Access Compliance Report

Public Rights-of-Way

Intersection ID: 48432	Main Street: WHITHORN_WY	Cross Street: SEAMILL_RD	Location: NW
ADA ID: 421B19D2D848	Ramp Type: Perp	Initial Pass/Fail: Pass	Overall Compliance: No
			Severity Score: 0.25

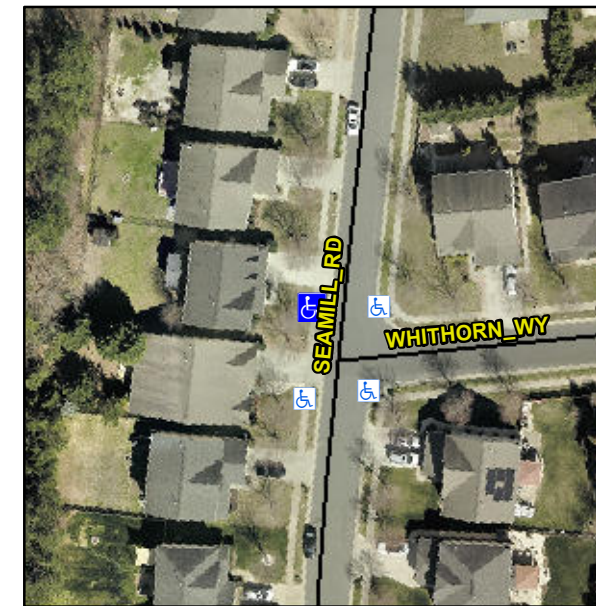
**R304.2.2-Perp, R304.3.2-Para,
R304.5.3**

Remove & Replace Landing.
